## WESTERN NUCLEAR, INC.

August 29, 2008

**Re: Western Nuclear Inc., Split Rock Uranium Mill Tailings Facility, Source Materials License SUA-56, Proposed Amendments to License Condition 74.**

Figure 1 - Sulfate in POE Wells

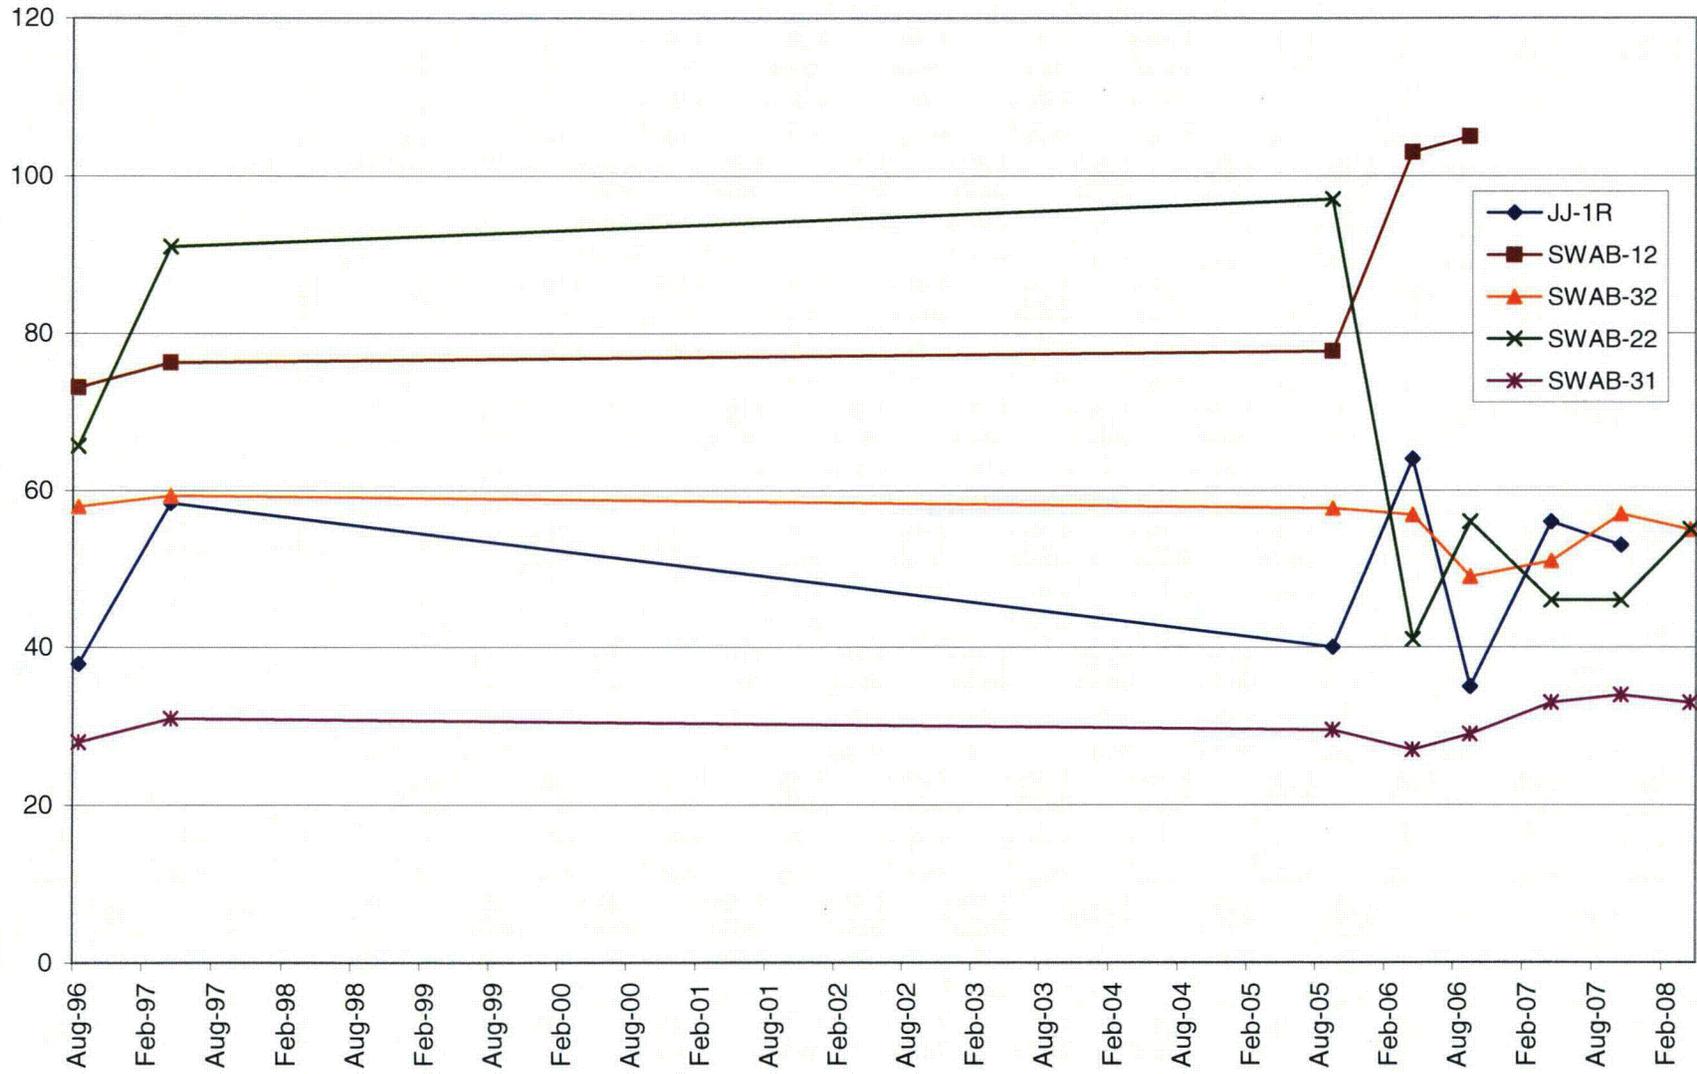
The existing license condition has trigger levels for the constituents for which ACLs have been established. Not all of the ACL constituents are mobile and therefore do not make good candidates for early indication of seepage. It has been shown that the best indicators of seepage at the site are uranium and sulfate. Further, uranium and sulfate are the two constituents that are measured on a semi-annual basis for these wells. Therefore these two constituents are proposed for trigger level values.

It is also proposed that the trigger limits be changed to be consistent with background concentrations. For example, the existing trigger limit for uranium is set at the MCL for uranium at 0.03 mg/l (except for well SWAB-32 which has been shown to have naturally occurring uranium at concentrations greater than the rest of the site). Site wide background values for uranium in the Split Rock Aquifer is 0.13 mg/l as documented in Table 3 of the 2006 NRC Environmental Assessment. However, it is recognized that the concentrations in some of the POE wells are less than the statistically derived background values and setting the trigger levels at the statistical background values might not be appropriate. Therefore it is proposed that the trigger levels be based on historic values measured in each of the POE wells.

Figures 1 and 2 show the historic uranium and sulfate values for the POE wells. Although there are limited data, a visual upper limit can be estimated that would be an appropriate trigger levels to indicate if conditions are different and further evaluation would be warranted. These visual limits for each well are proposed for trigger levels in Table 2. It is possible, when additional data are available, that a statistically based intra-well trigger value could be calculated for each well. In the interim, the proposed trigger levels will provide the necessary early indication of changing conditions.

**Comply with the following ground water trigger levels at the point of exposure wells which are defined as wells JJ-1R, SWAB-12, SWAB-22, SWAB 31 and SWAB-32:**

Well	Sulfate	Uranium
JJ-1R	100 mg/l	0.03 mg/l
SWAB 12	150 mg/l	0.1 mg/l
SWAB 22	150 mg/l	0.05 mg/l
SWAB 31	50 mg/l	0.05 mg/l
SWAB 32	100 mg/l	0.3 mg/l

Figure 3 - Surface Water Sulfate

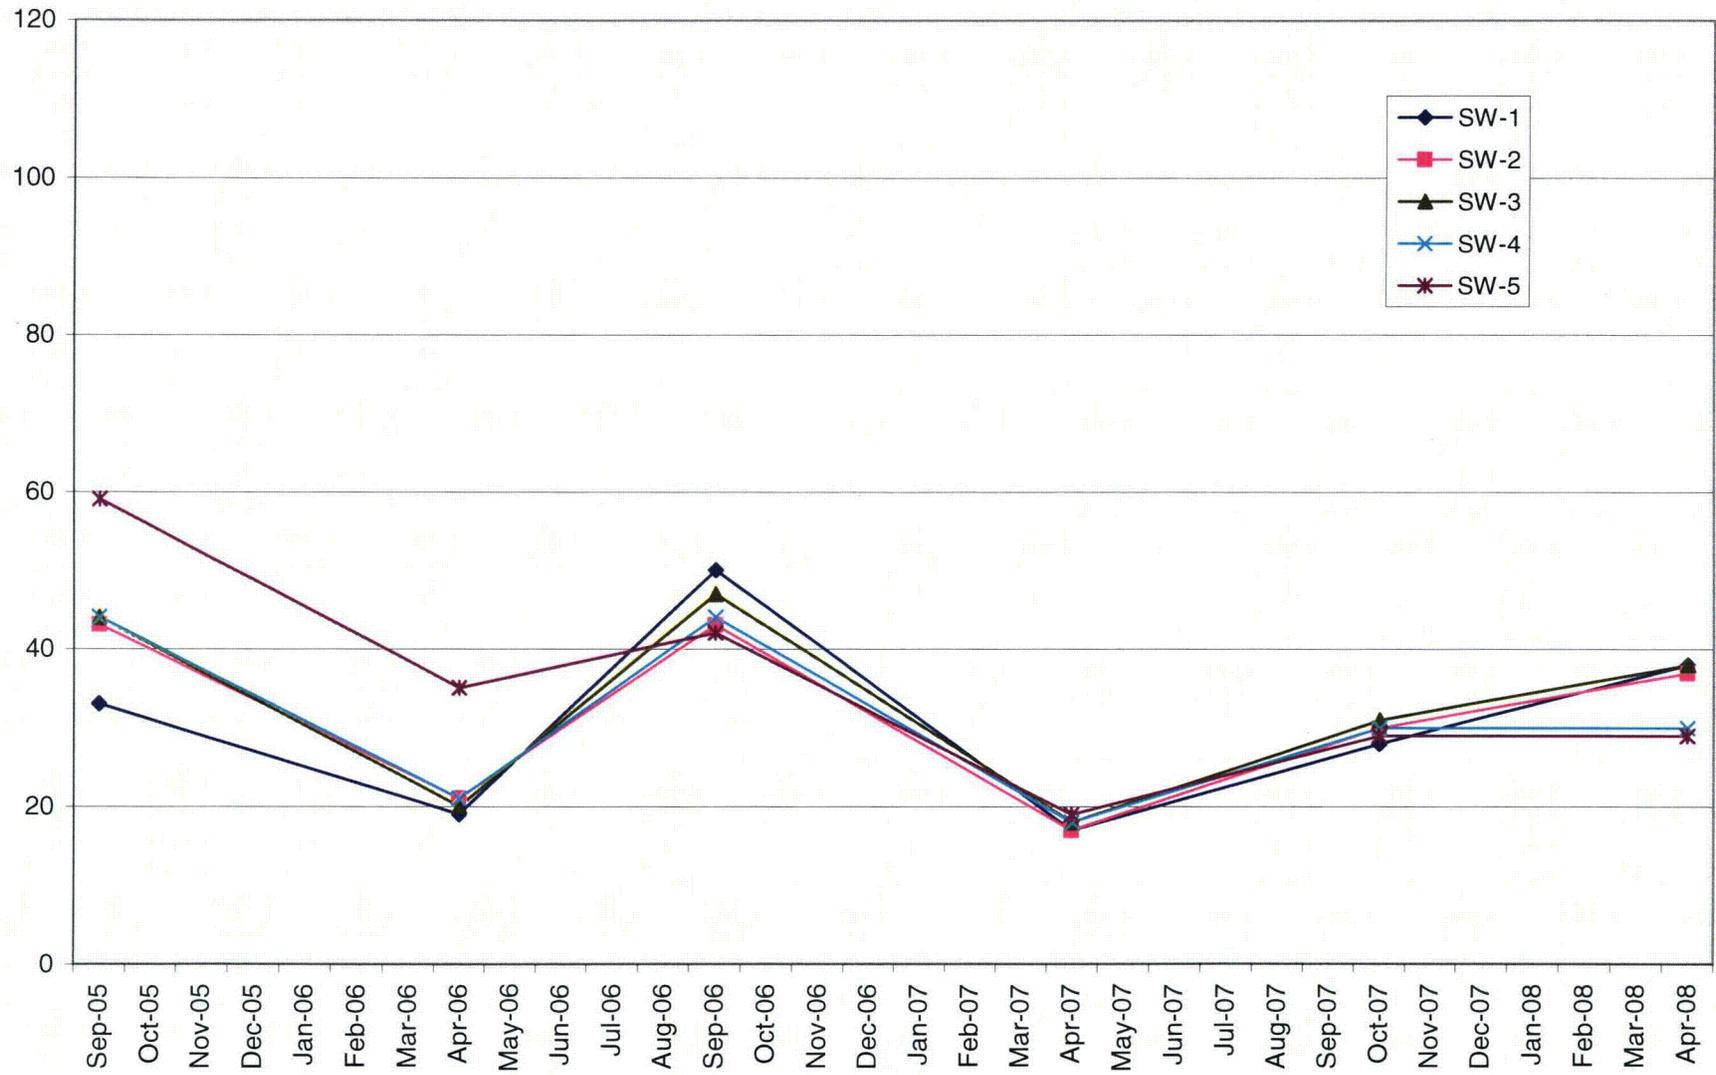
As with the groundwater POE locations, sulfate and uranium are the best indicators of seepage and these parameters are monitored semi-annually. The trigger levels were also determined in the same manner as they were for the groundwater POE wells. Figures 3 and 4 show the historic uranium and sulfate values

for the surface water sampling locations. It is proposed that the uranium trigger level remain at 0.03 mg/l and the sulfate trigger level be set at 100 mg/l. As with the groundwater trigger levels, it might be possible to change the trigger levels in the future to a more statistically based value once more data have been collected.

**Comply with the following surface water trigger levels at surface water monitoring locations SW-2, and SW-5: natural uranium = 0.03 mg/l and sulfate = 100 mg/l.**
